STAFF REPORT

SUBJECT: FP-2020-0001
Shelburne South No. 1

Final plat consisting of 59 buildable lots and 16 common lots on 16.61 acres of land in the R-8 zoning district.

B. Final Plat (dated: 8/18/20)

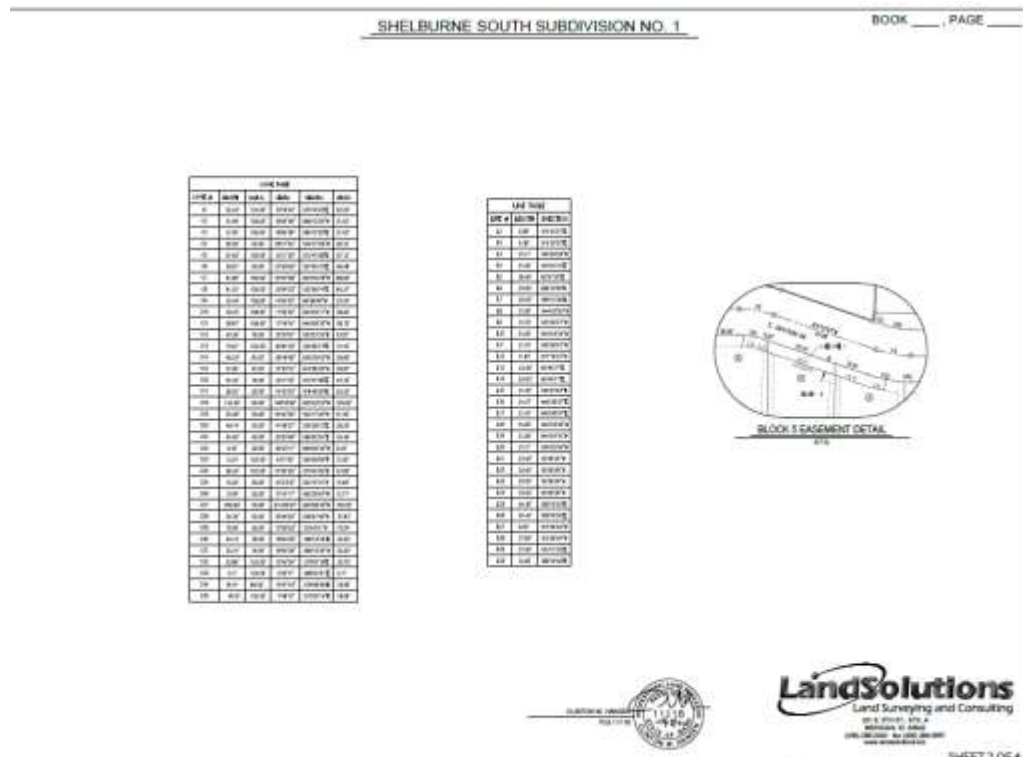
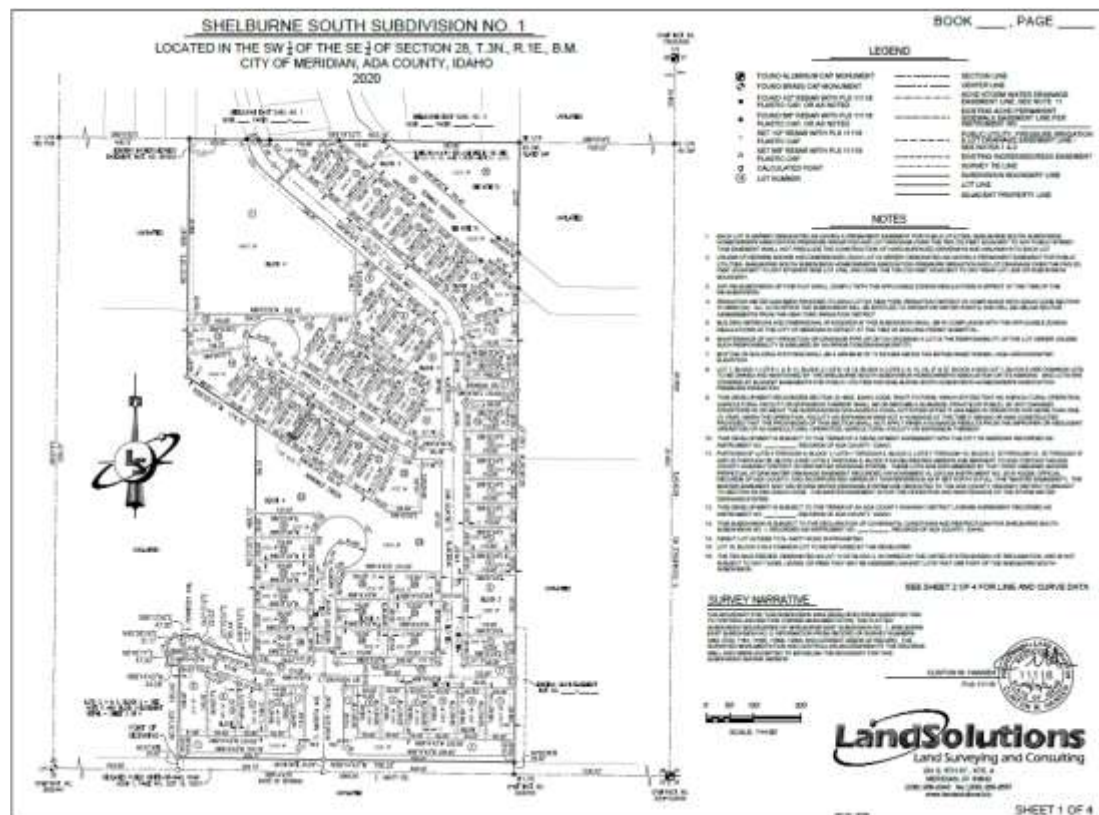
3. Prior to submittal for the City Engineer's signature, have the Certificate of Owners and the accompanying acknowledgement signed and notarized.
4. The final plat prepared by Land Solutions, stamped by Clinton W. Hansen, dated: 8/18/2020, included in Section V.B shall be revised as follows:

- a. Note #10: Include the recorded instrument number of the Development Agreement (#2020-138124).
 - b. Note #12: Include the recorded instrument number of the

- c. Note #13: Include the recorded instrument number of the CC&R's.
 - d. Include the recorded Book and Page numbers for Shelburne East Subdivision No. 1 and No. 2 graphically depicted on Sheet 1.

- e. Include the recorded instrument number for the existing slope easement graphically depicted on Sheet 1.
 - f. Include the recorded instrument number of the existing ACHD permanent sidewalk easement line in the Legend on Sheet 1.

A copy of the revised plat shall be submitted for City Engineer signature.

LANDSCAPE IMPROVEMENT PLANS FOR SHELburne SOUTH - PHASE 1 SUBDIVISION

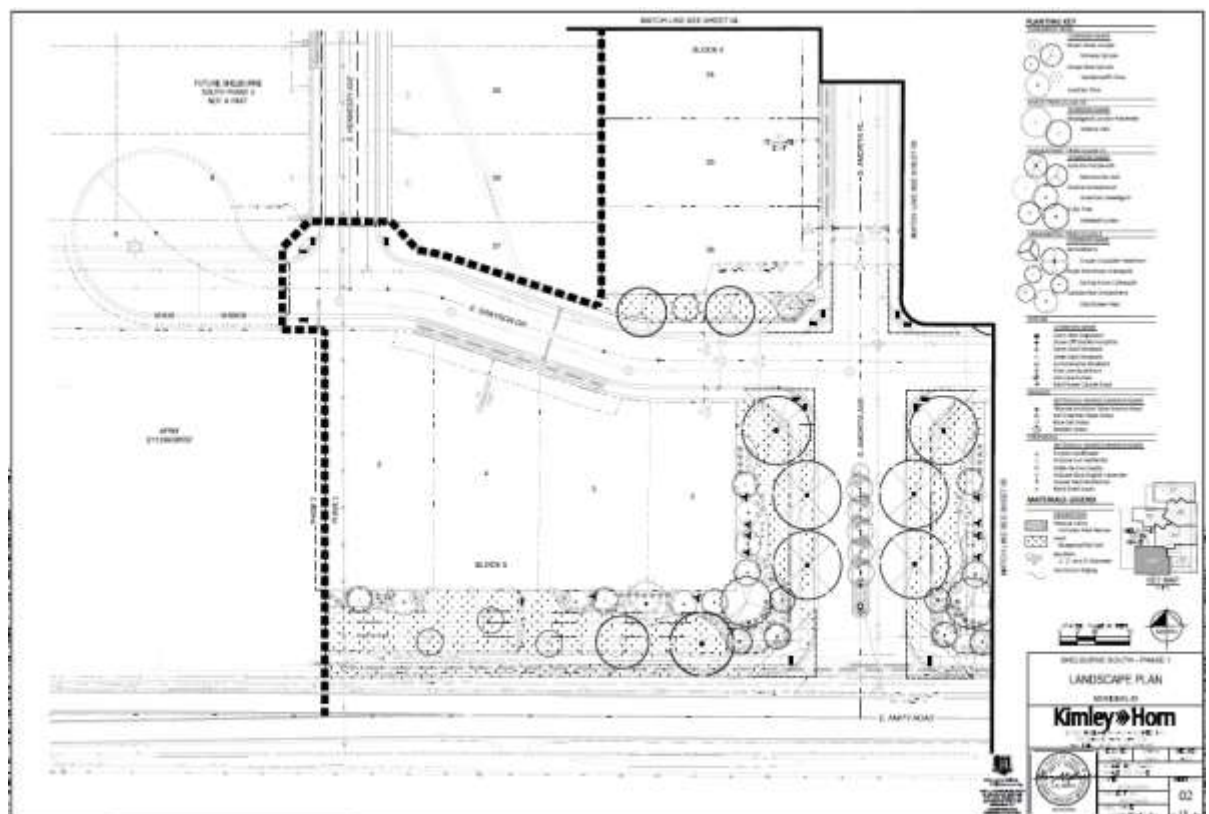
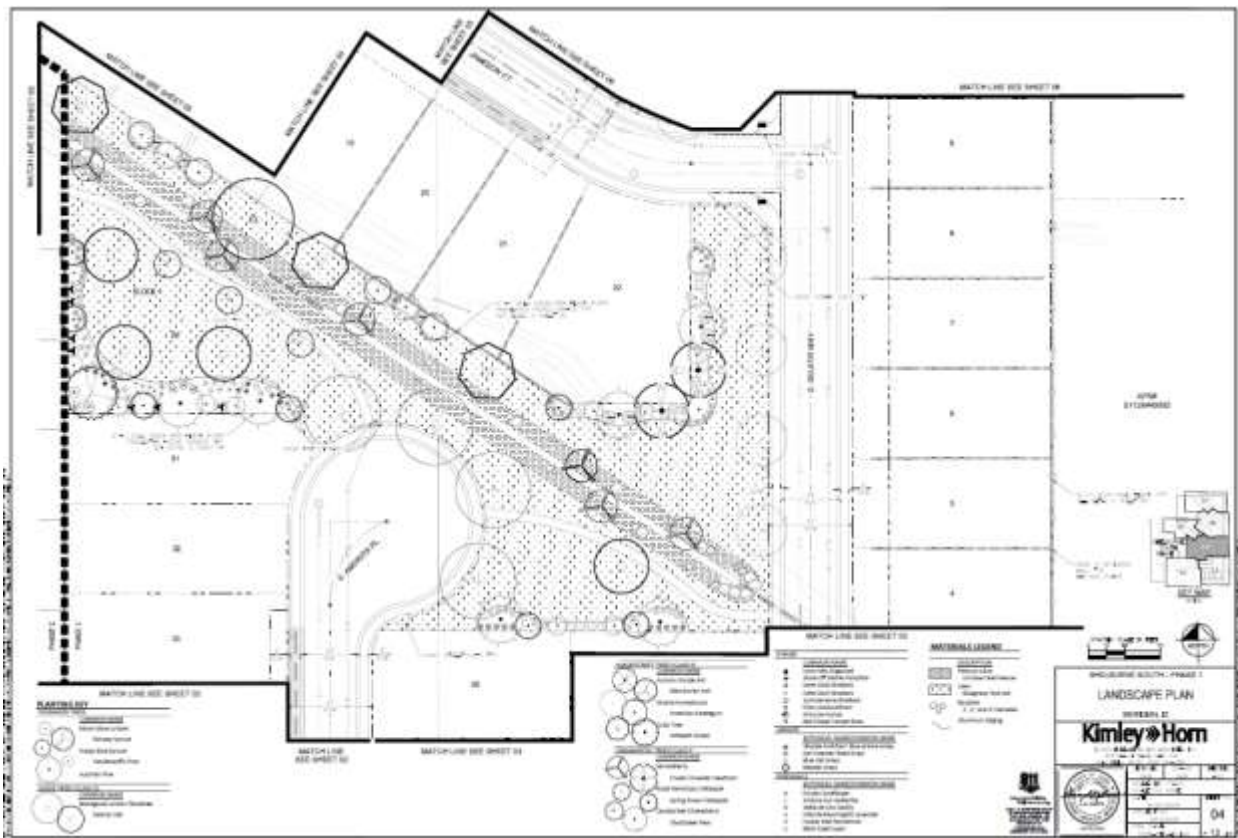
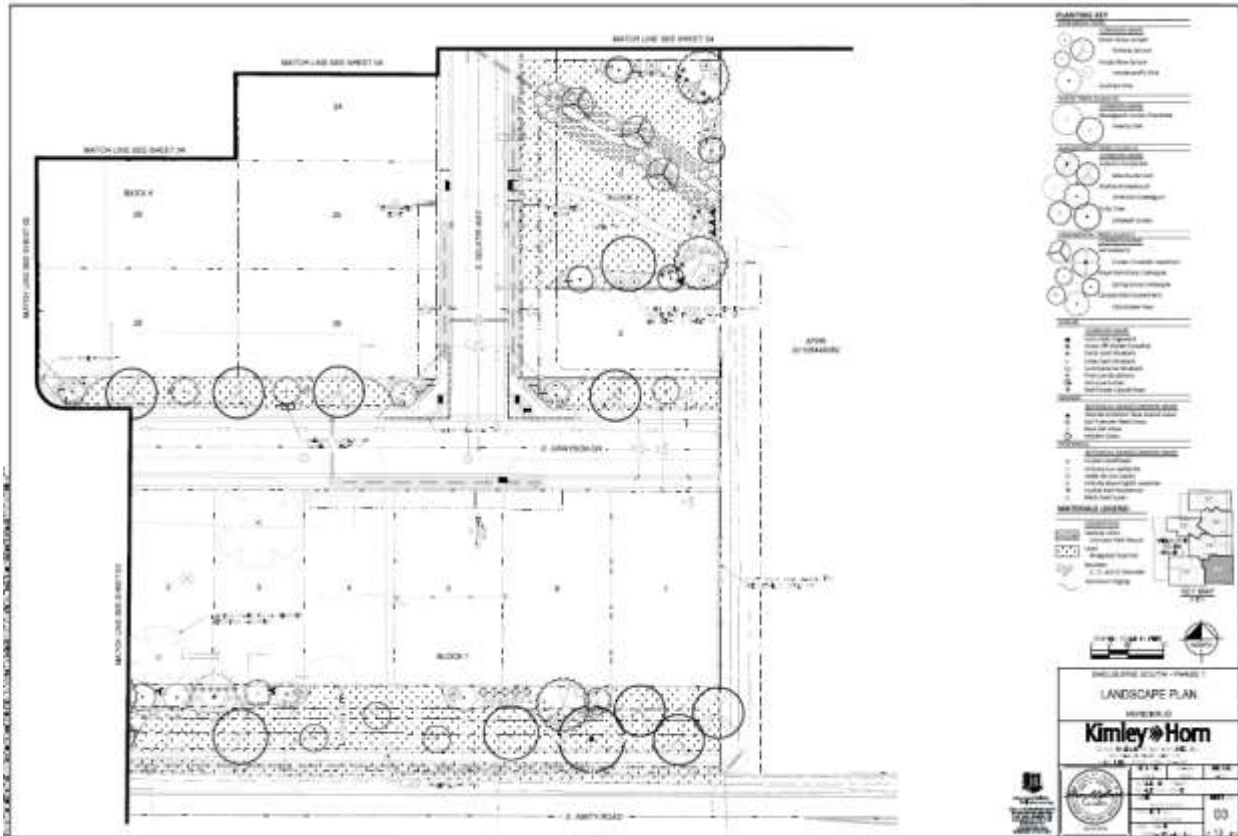
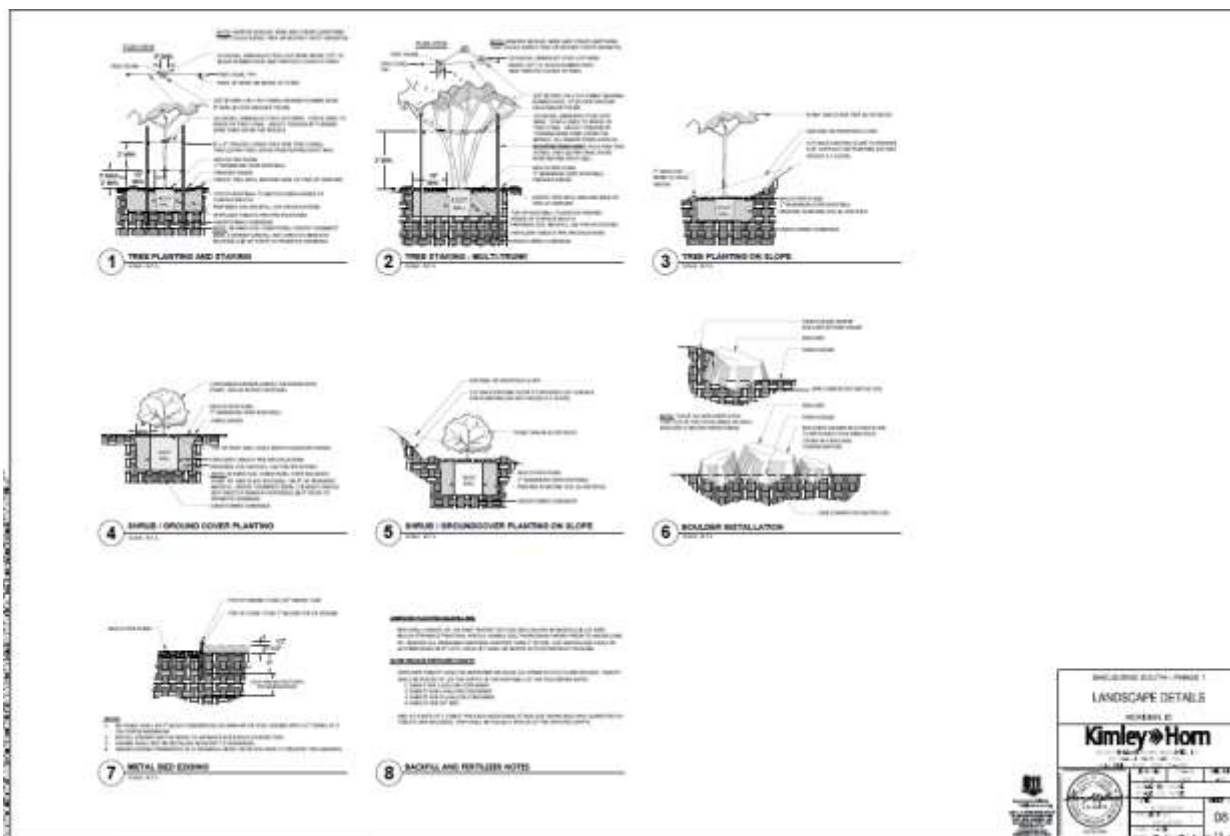
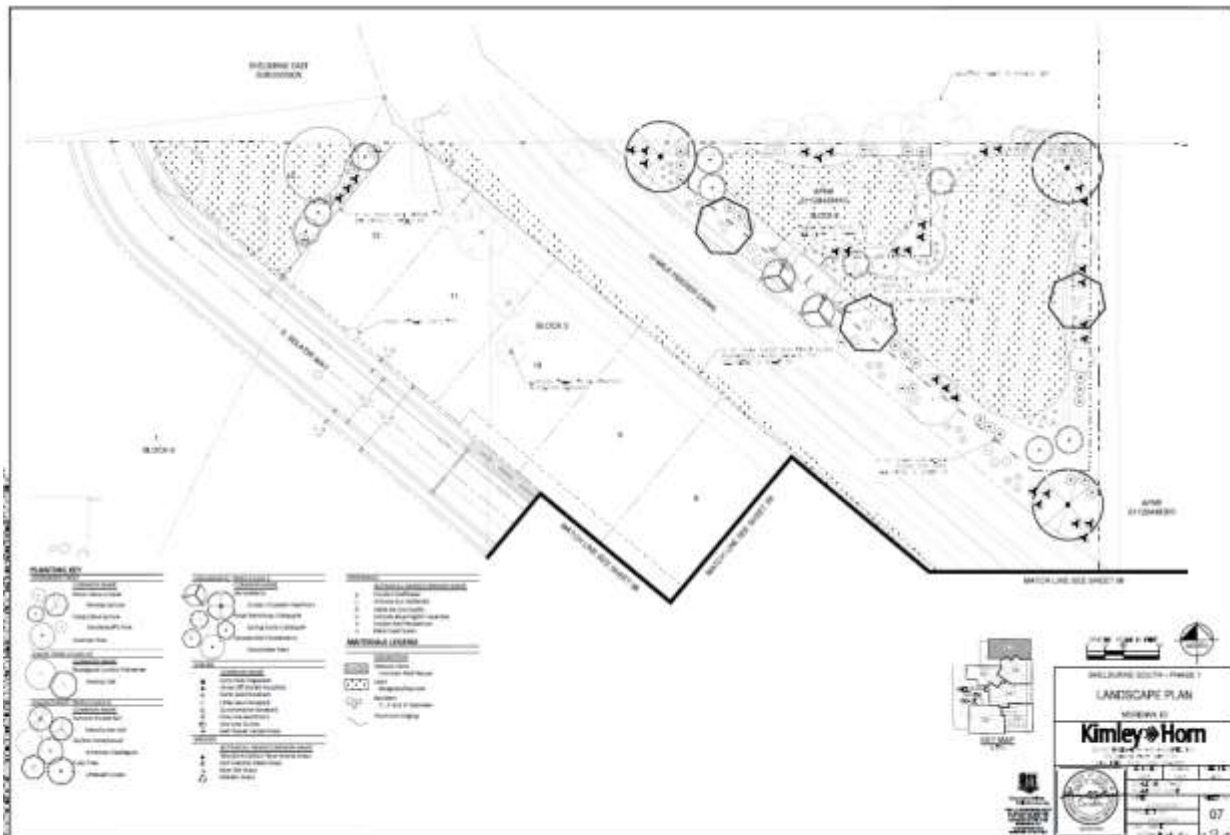
5. The landscape plan prepared by Kimley-Horn, dated 08/26/2020, included in Section V.C, shall be revised as follows:
 - a. Depict mitigation trees and calculations on the plan in accord with the standards listed in UDC 11-3B-10C.5. *Coordinate with Matt Perkins, the City Arborist, to determine mitigation requirements.*

- b. Revise the configuration of the pathway on Lot 3, Block 2 so that it runs parallel with the creek in closer alignment with the pathway on Lot 23, Block 4.

- c. If the unimproved right-of-way of E. Amity Rd. is 10 feet or greater from the edge of pavement to edge of sidewalk or property line, the Developer is required to maintain a 10 foot compacted shoulder meeting the construction standards of ACHD and landscape the remainder with lawn or other vegetative ground cover as set forth in UDC 11-3B-7C.5. A license agreement for improvements within the right-of-way is required between the property owner and ACHD.

- d. Depict 5-foot wide landscape strips on each side of the multi-use pathway that comply with the standards listed in UDC 11-3B-12C. *A mix of trees, shrubs, lawn and/or other vegetative groundcover is required.*
